Access Compliance Report

Public Rights-of-Way

(Curb Ramps)

Intersection ID: 5009	Main Street: OAK_DR	Cross Street: FOX_POINT_DR	Location: SE
ADA ID: ADE24FC85DC5	Ramp Type: PerpDiag	Initial Pass/Fail: Fail	Overall Compliance: No
Severity Score: 32.5			
Codes/Mitigation Info/Possible Solution		Field Measurements/Component Compliance

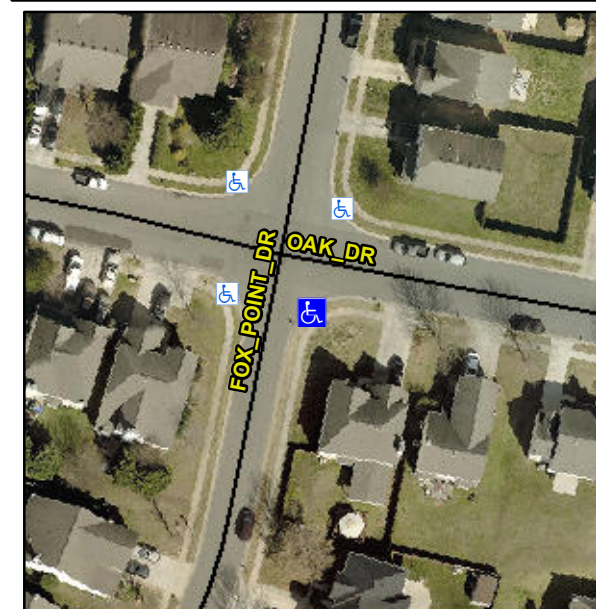
R304.5.1, R302.7

Compliance	Description	Data	Compliance	Description	Data
N/A	Ramp Length (in)	48.0	Yes	Ramp Slope (%)	6.2
No	Ramp Width (in)	34.5	Yes	Ramp XSlope (%)	1.6
N/A	Flare Type LT	N/A	N/A	Flare Type RT	N/A
N/A	Flare Slope LT (%)	N/A	N/A	Flare Slope RT (%)	N/A
N/A	Flare Traversable LT?	N/A	N/A	Flare Traversable RT?	N/A
N/A	Landing Length (in)	N/A	N/A	DWS Provided?	N/A
N/A	Landing Width (in)	N/A	N/A	DWS Contrast?	N/A
N/A	Landing Slope (%)	N/A	N/A	DWS Length (in)	N/A
N/A	Landing X Slope (%)	N/A	N/A	DWS Full Width?	N/A
N/A	Landing Curb? (Y/N)	N/A	N/A	DWS Offset (in)	N/A
N/A	Shared Landing?	N/A			
N/A	Gutter Ponding?	N/A	N/A	Gutter Slope (%)	N/A
N/A	Gutter Lip Ht (in)	2.0	N/A	Gutter X Slope (%)	N/A
N/A	Painted X Walk1?	No	N/A	Painted X Walk2?	No
	X Walk 1 Direction	To NE		X Walk 2 Direction	To NW
N/A	X Walk 1 Width (in)	N/A	N/A	X Walk 2 Width (in)	N/A
	X Walk 1 Slope (%)	2.6		X Walk 2 Slope (%)	6.1
	X Walk 1 X Slope (%)	6.2		X Walk 2 X Slope (%)	5.8

N/A	Ramp inside XWalk1?	N/A	N/A	Ramp inside XWalk2?	N/A
	Road Slope (%)	1.5	N/A	Clear Space?	N/A
	Road X Slope (%)	7.6	N/A	Clear Space to XWalk (in)	N/A
N/A	Any Obstructions?	N/A	N/A	Storm Grate/Utility Hazard?	N/A
	Obstruction Type			Storm Grate/Utility Type	
		N/A			N/A
		No		Surface Condition? (G/P)	Poor

Remove & Replace Curb Ramp With Two New Directional Ramps or Equivalent.
